SUBJECT: Addendum No. 1
City of Lookout Mountain, GA
Chickamauga Trail Pump Station Improvements

ADDENDUM NO. 1

CHICKAMAUGA TRAIL PUMP STATION IMPROVEMENTS

CITY OF LOOKOUT MOUNTAIN, GEORGIA
GEFA LOAN NUMBER: GF2024017
CTI PROJECT NO. G24017-01

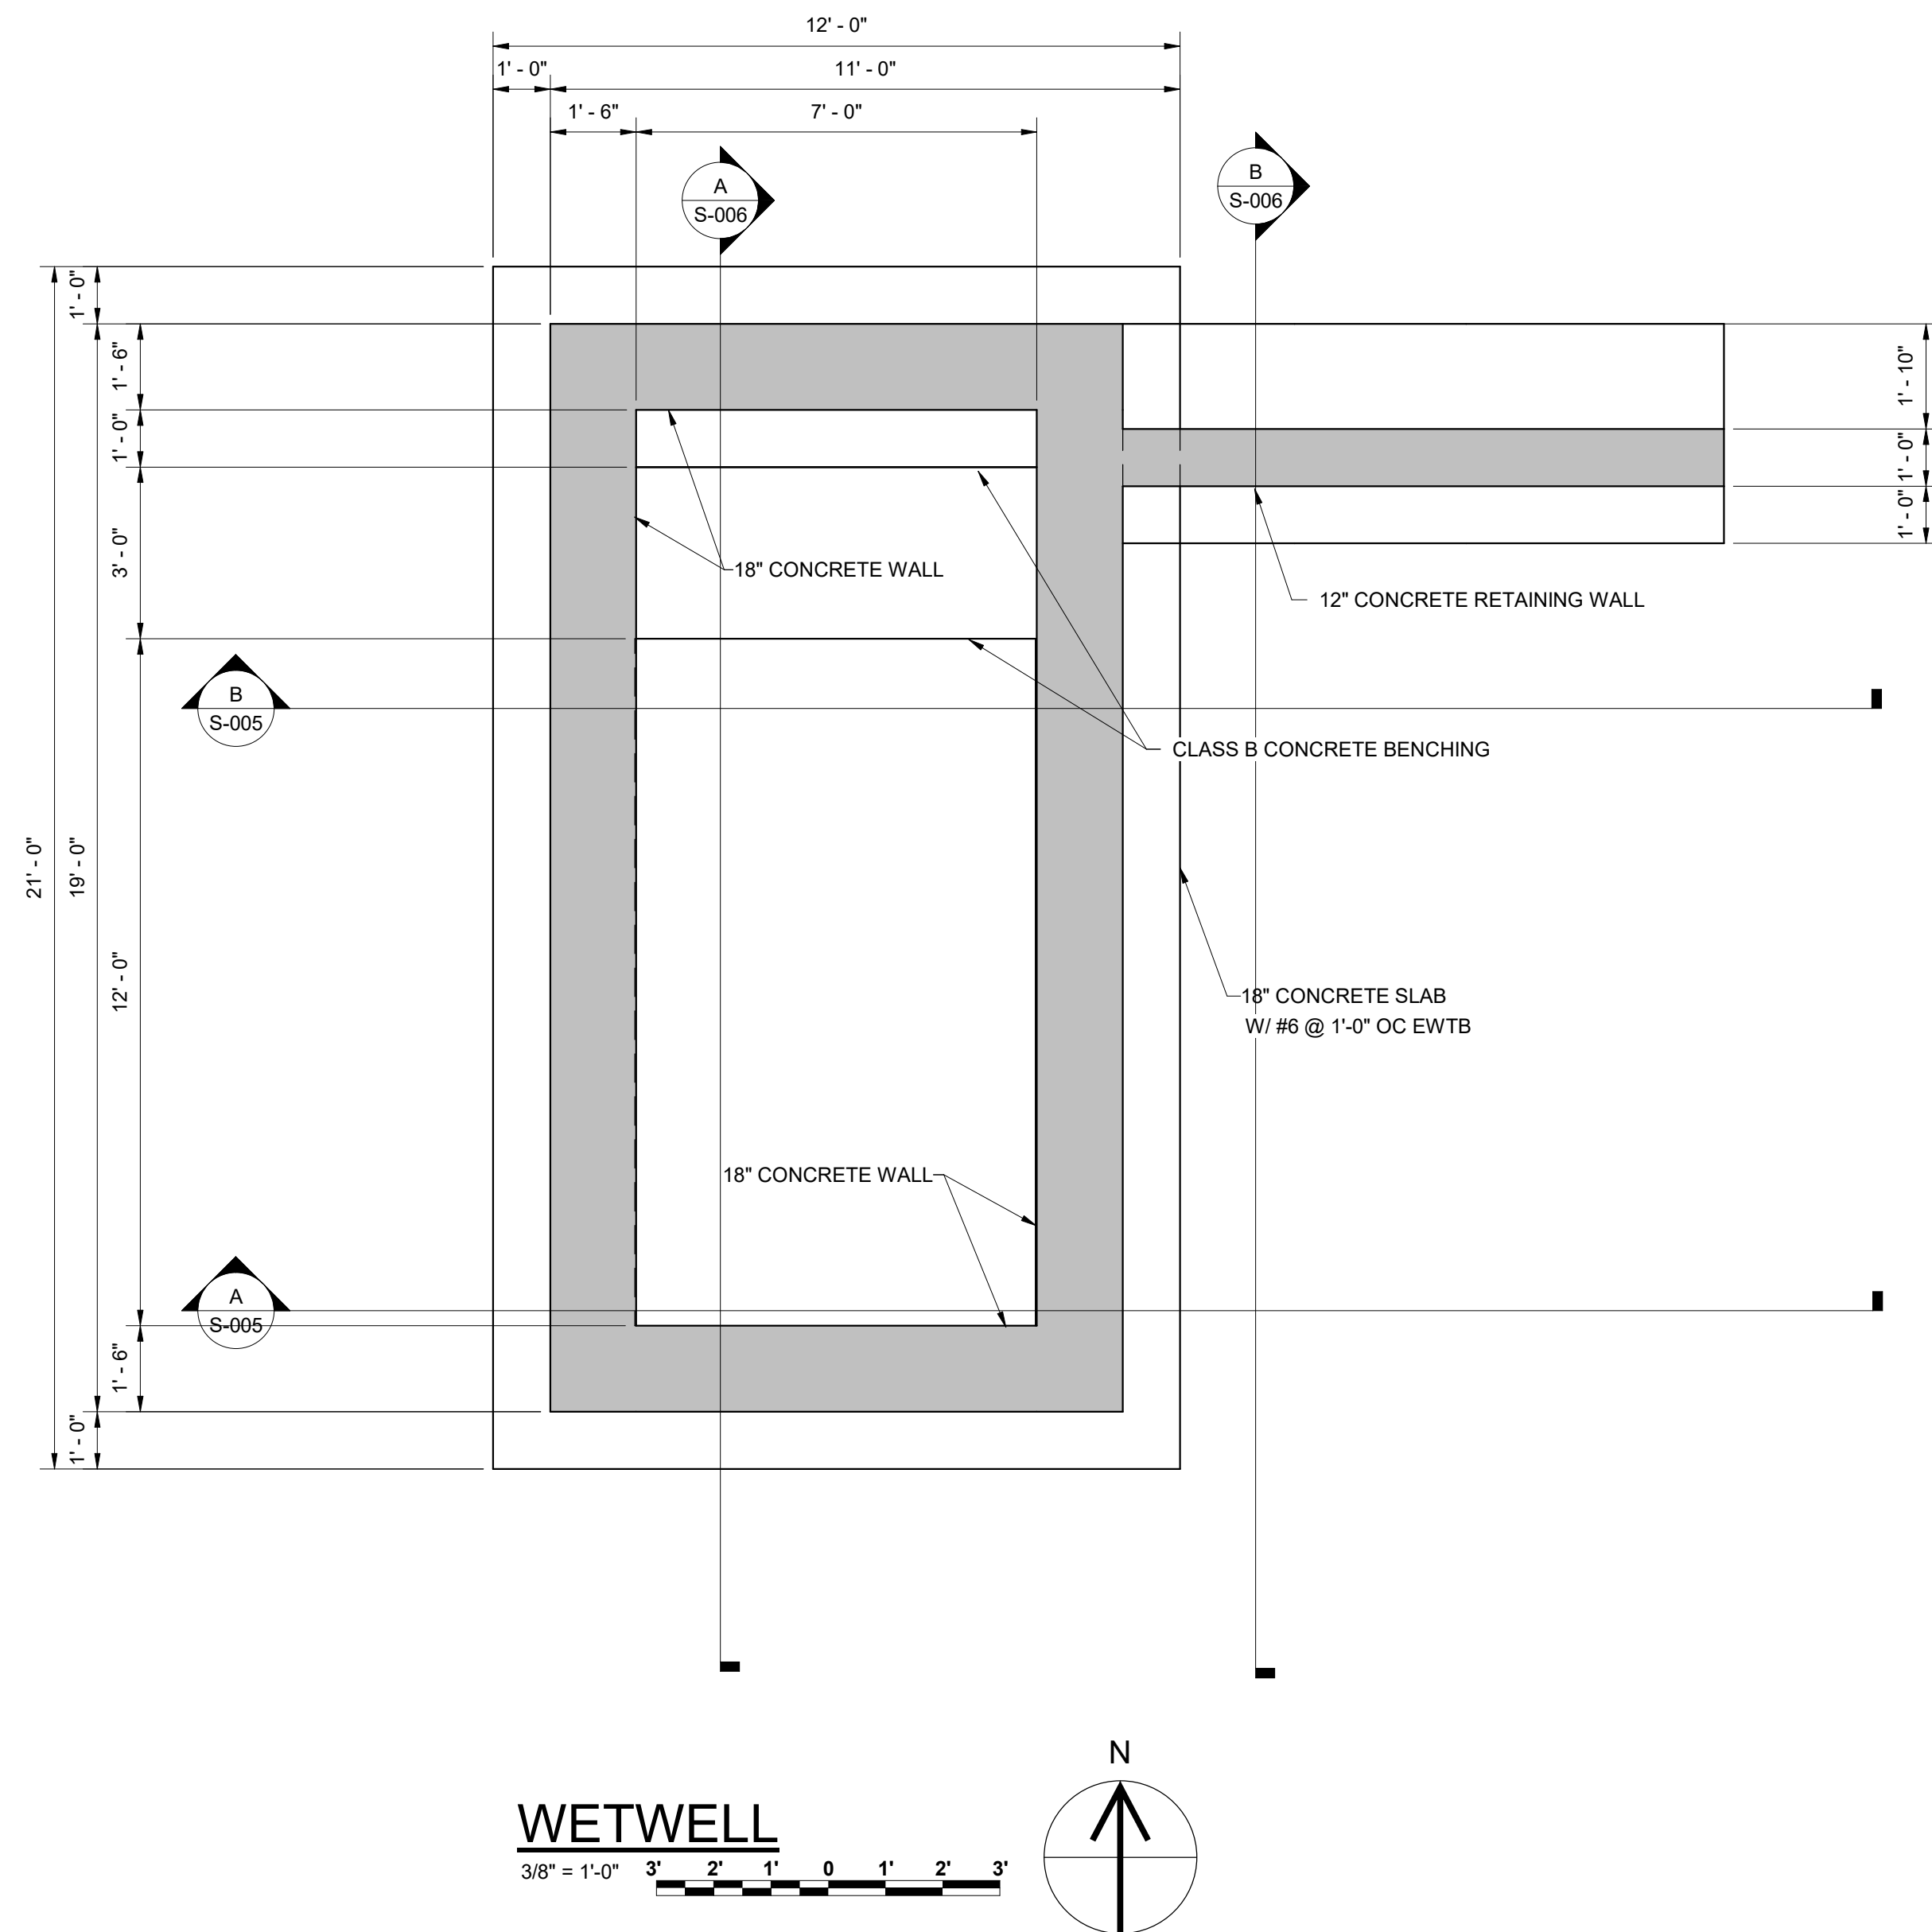
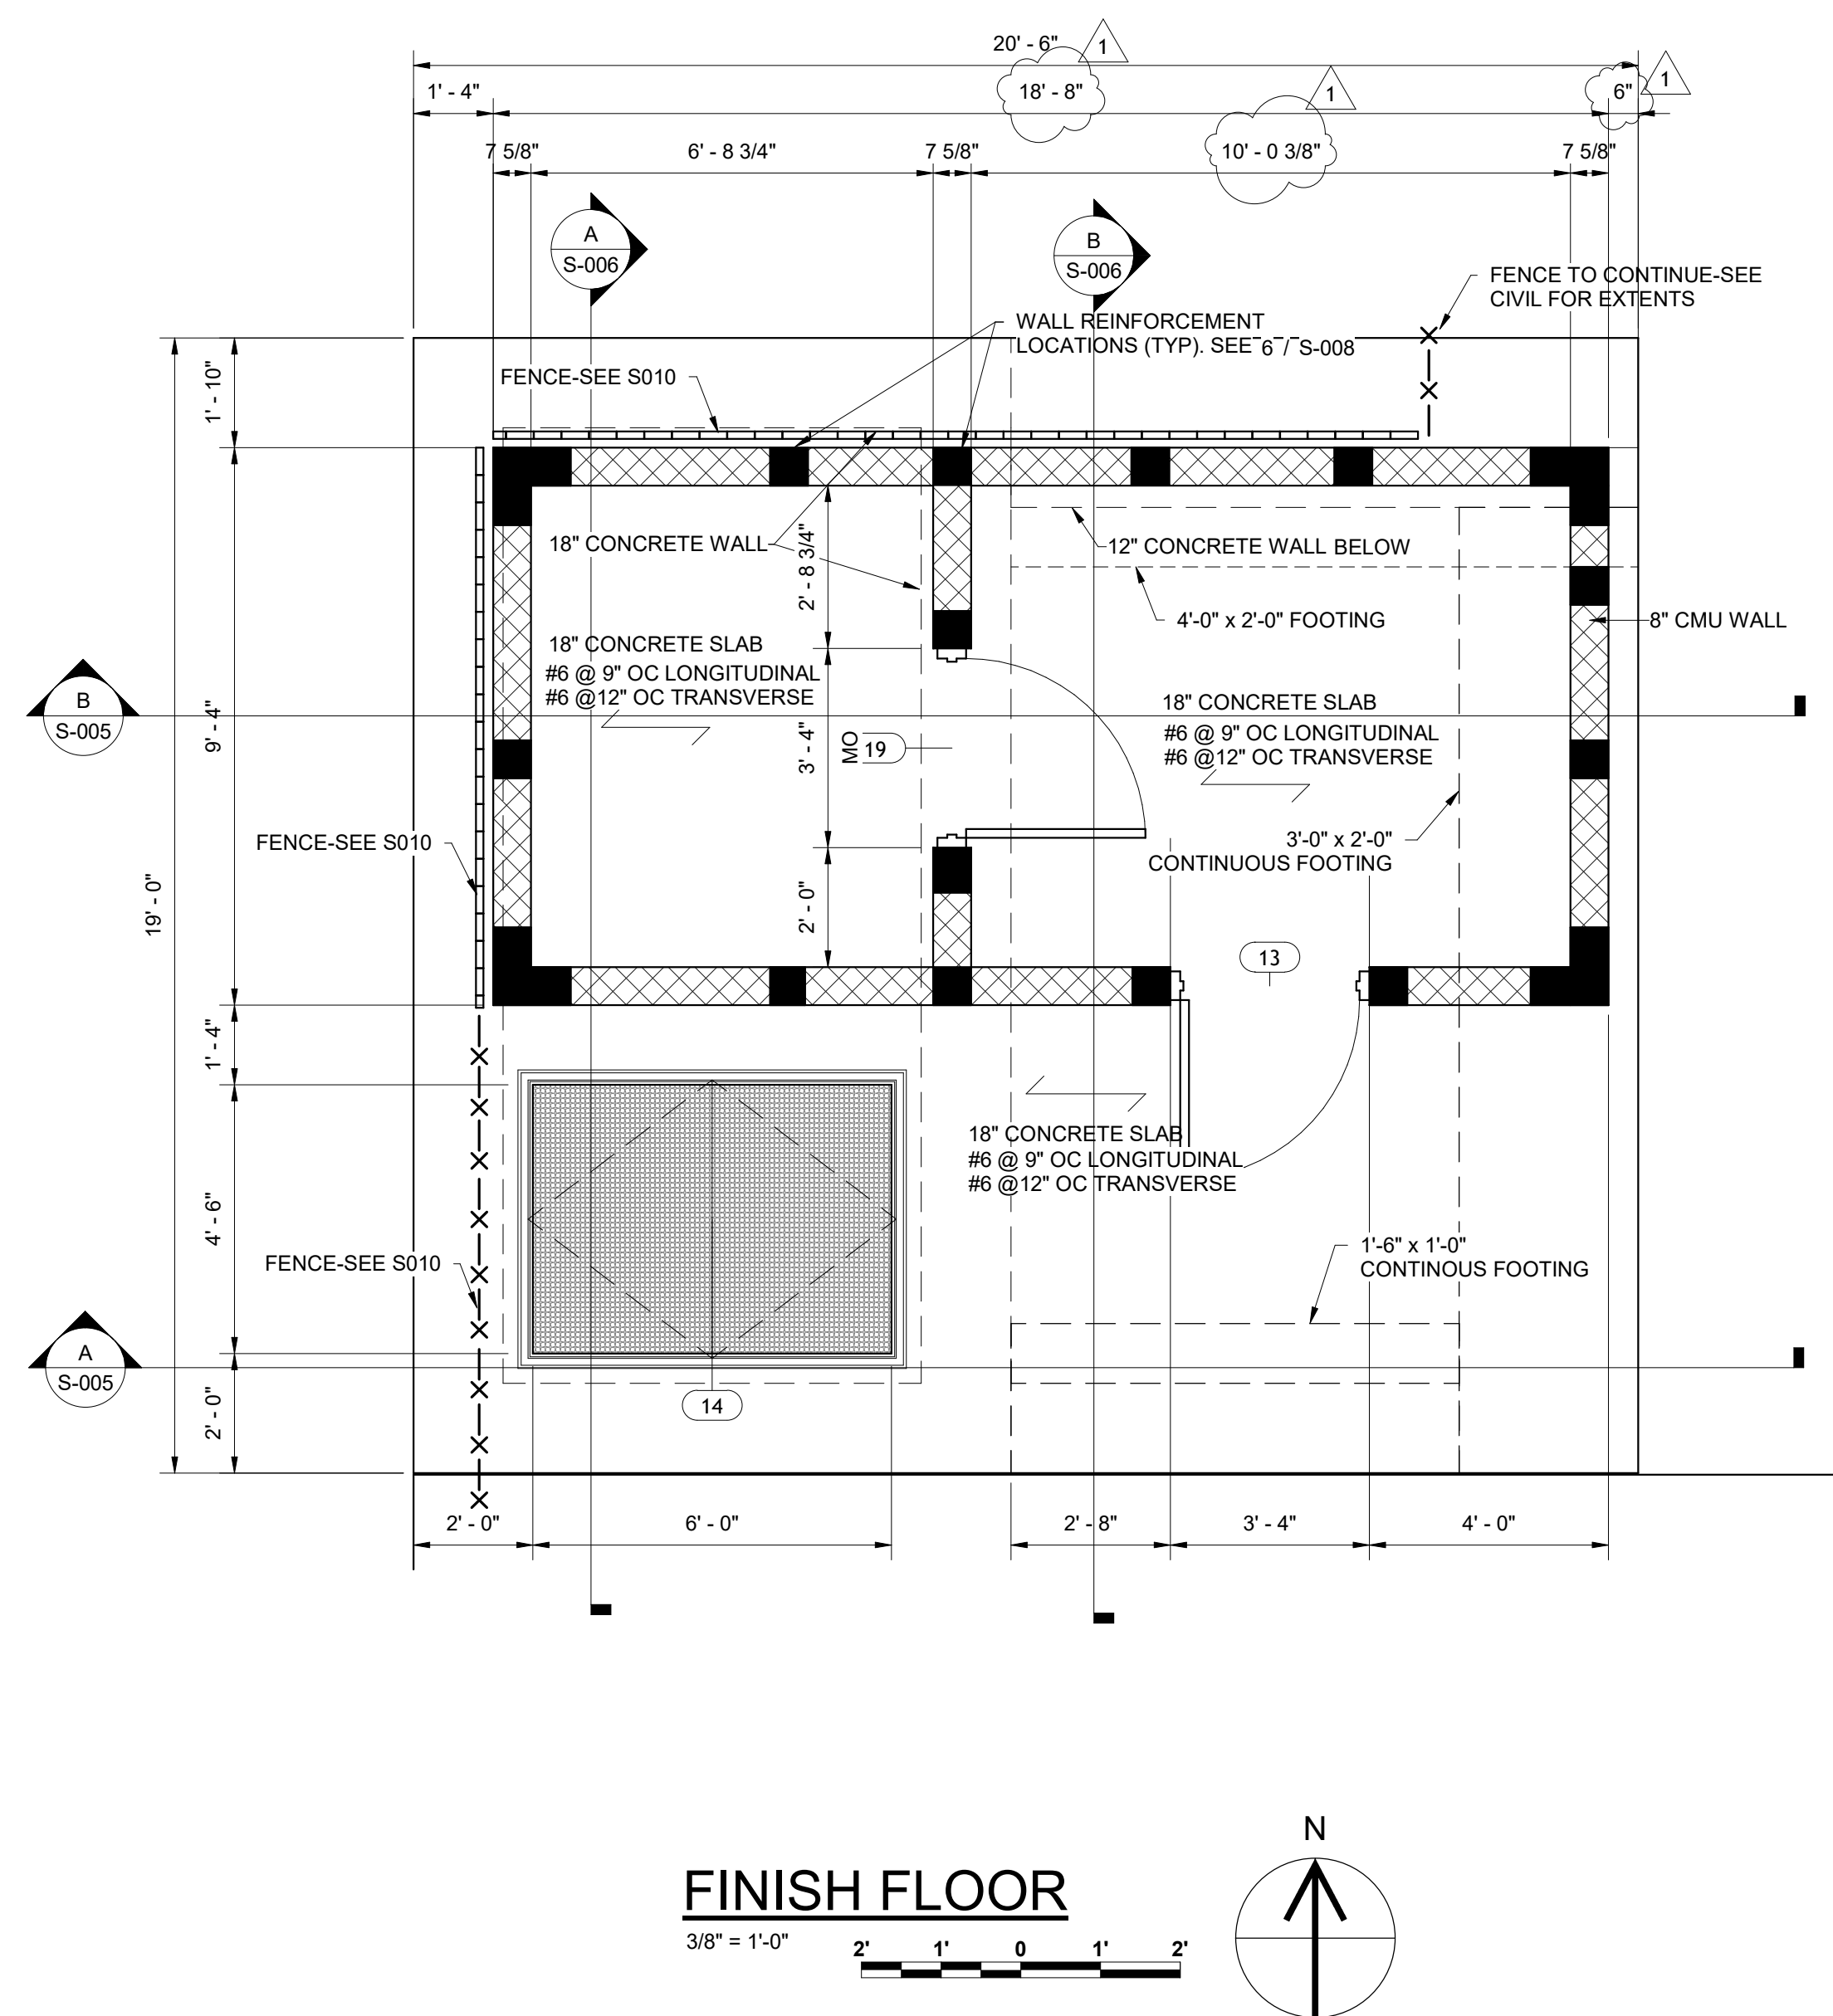
CTIENGINEERS 1122 RIVERFRONT PARKWAY CHATTANOOGA, TN 37402 423-267-7613	CITY OF LOOKOUT MOUNTAIN GEORGIA CHICKAMAUGA TRAIL PUMP STATION IMPROVEMENTS	DESIGNED JBM DRAWN JBM	REVISIONS				
			NO.	DESCRIPTIONS	DATE	BY	APP'D
			1	LENGTHENED MASONRY BUILDING	09/25	JBM	KGP
	WETWELL & FOUNDATION PLAN	CHECKED KGP					
		APPROVED KGP/D					
		THIS DRAWING IS AN INSTRUMENT OF SERVICE OWNED BY CTI ENGINEERS, INC. (CTI), WHICH SHALL RETAIN ALL STATUTORY AND COMMON LAW RIGHTS, INCLUDING COPYRIGHTS. THIS DRAWING SHALL NOT BE SCANNED, COPIED, OR REPRODUCED IN ANY MANNER WITHOUT THE WRITTEN CONSENT OF CTI. CTI IS NOT RESPONSIBLE FOR CONSEQUENCES OF ANY REUSE OF THIS DRAWING OR PORTIONS THEREOF.					
JOB NO. G24017-01							
ISSUE DATE 03/28/2025							
DRAWING NO. S-002.1
